CHANGED LIMIT OF TREATMENT AND PAVEMENT MARKINGS DUE TO CONFLICT WITH ANOTHER PROJECT:
 * CASTLETON, CASTLETON, CASTLETON-WEST RUTLAND AC STP 2908, AC STP 2909, AC STP 2705

INTERCHANGE NO. 5 PAVEMENT MARKING DETAIL SHEET	PROJECT NAME: FAIR HAVEN-RUTLAND TOWN	PLOT DATE: 23-MAY-2013 11:41
	PROJECT NUMBER: NH SURF(22)	DRAWN BY: PVT. MGT.
	FILE NAME: I0bI06/I0bI06.dgn	CHECKED BY: PVT. MGT.
	PROJECT LEADER: M. FOWLER DESIGNED BY: PVT. MGT.	SHEET 14 OF 24

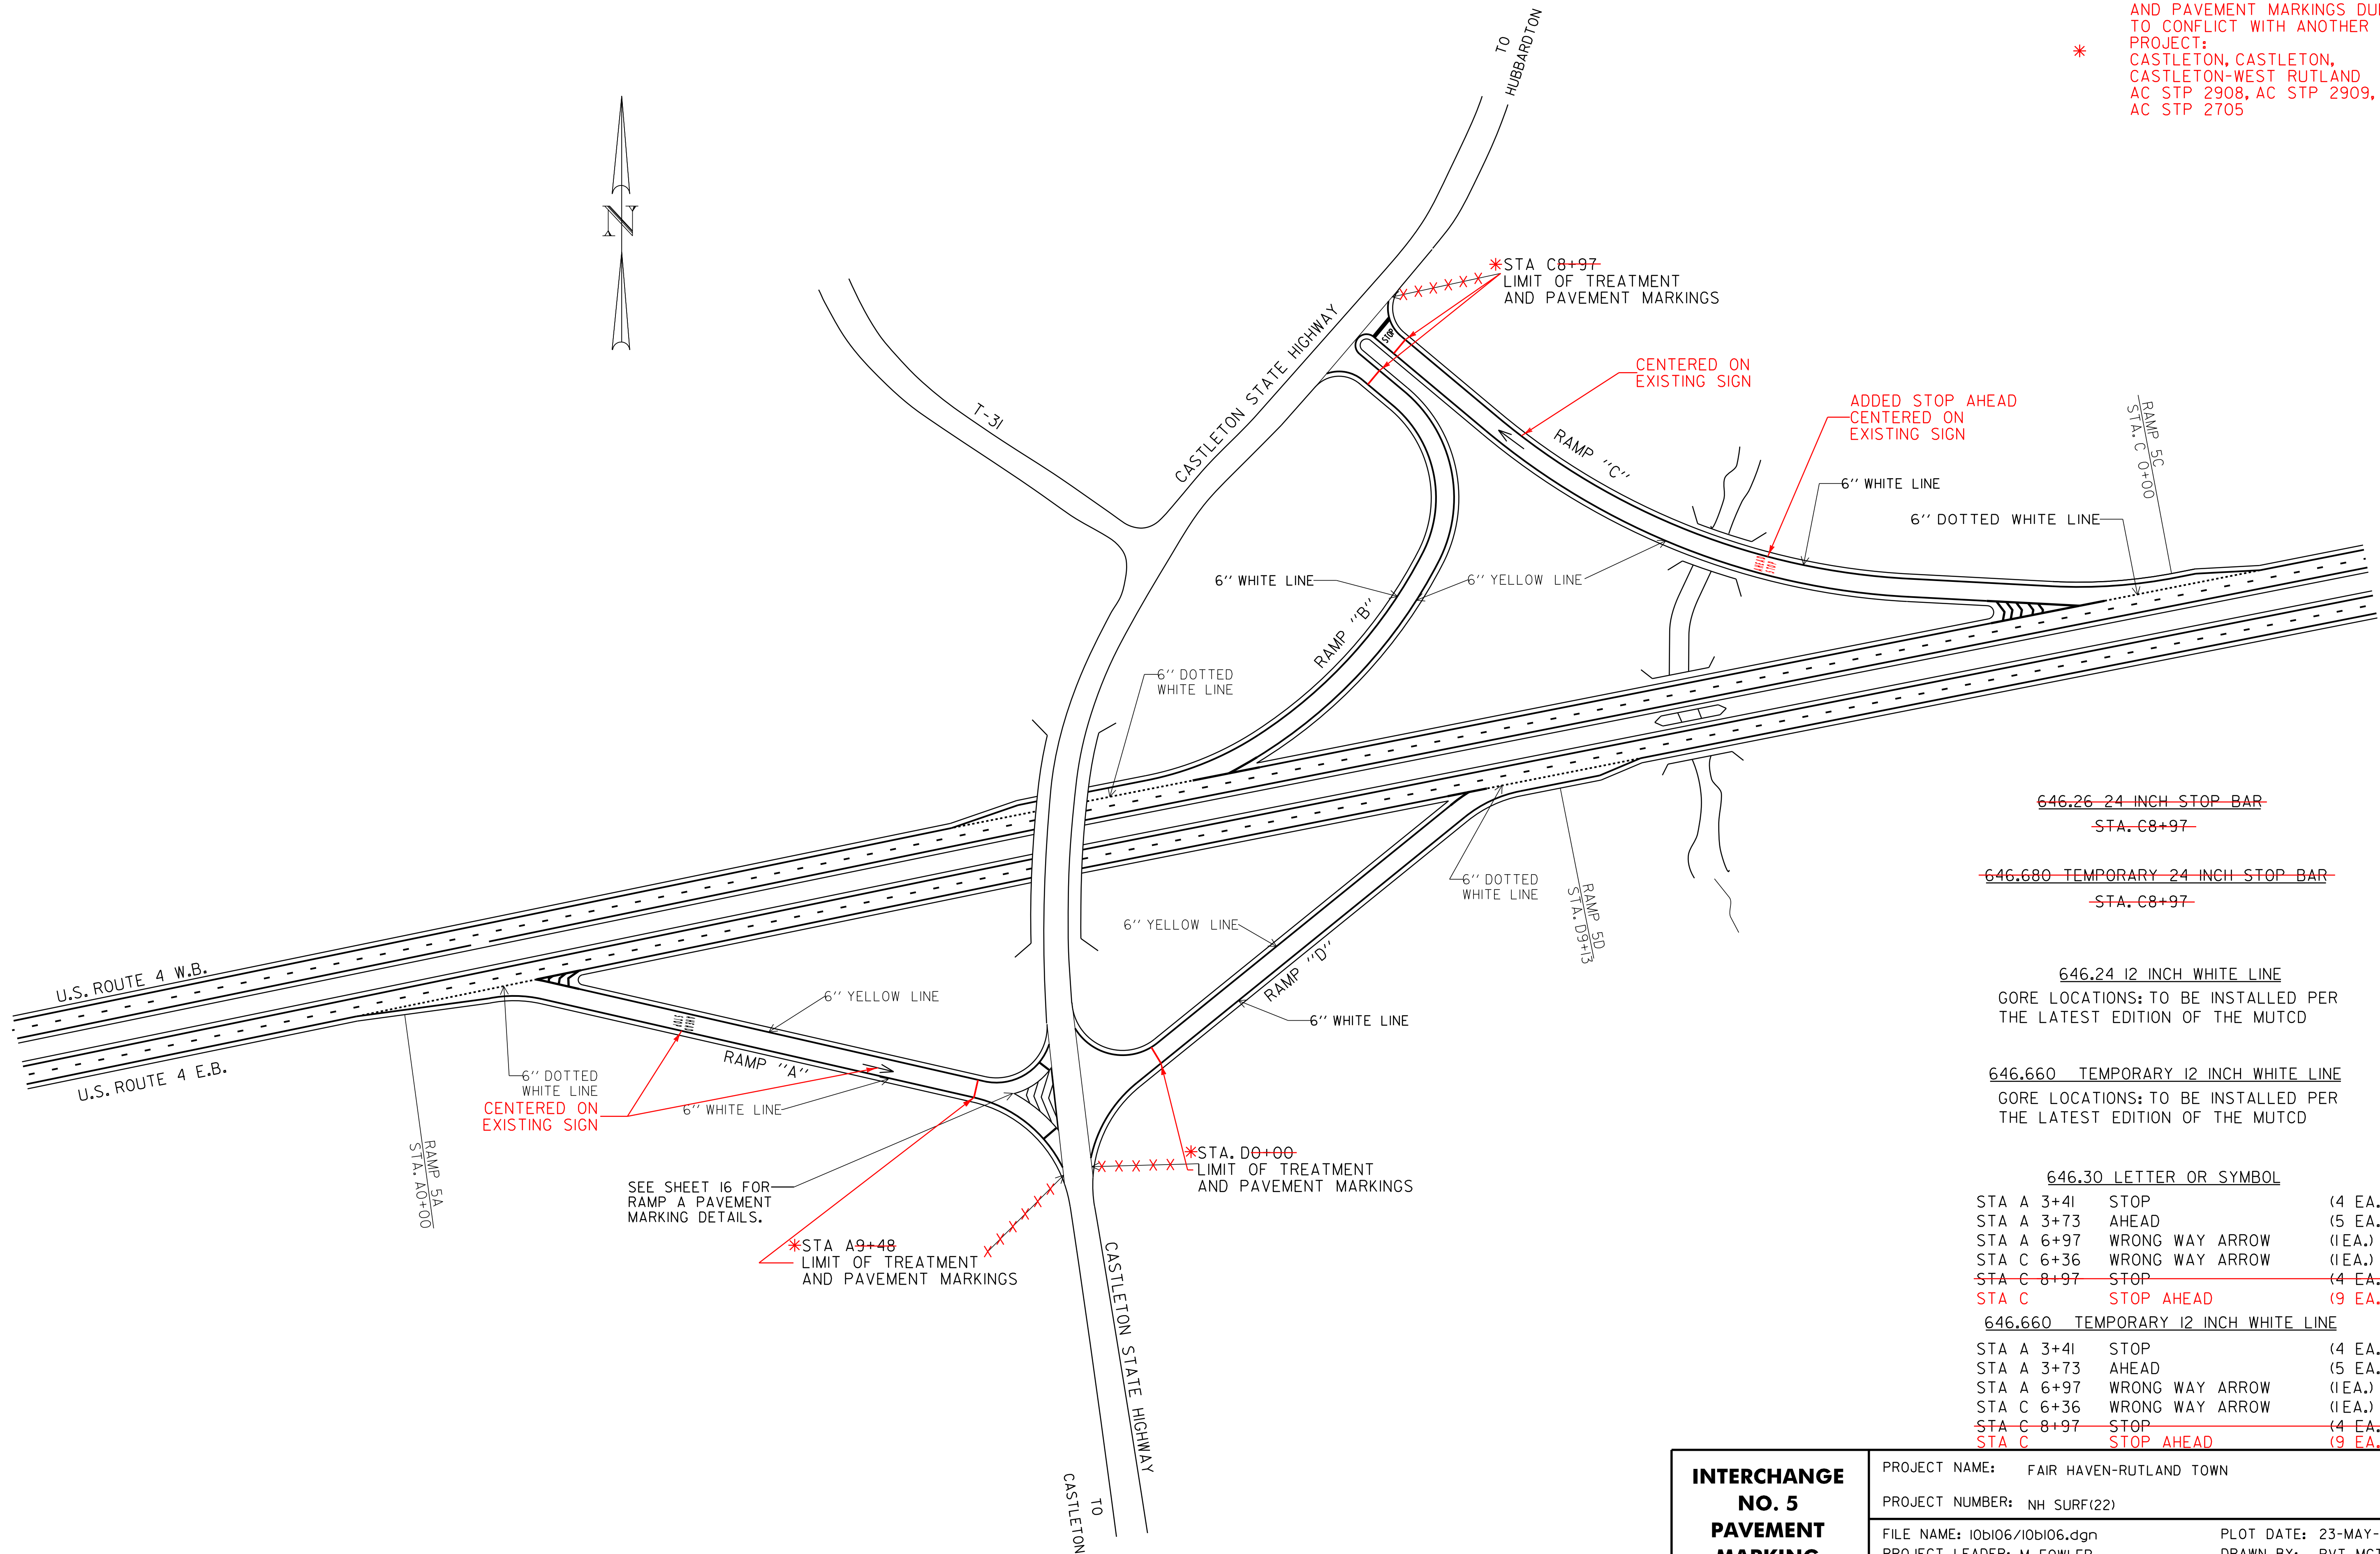
~~646.26 24 INCH STOP BAR
 STA. C8+97~~

~~646.680 TEMPORARY 24 INCH STOP BAR
 STA. C8+97~~
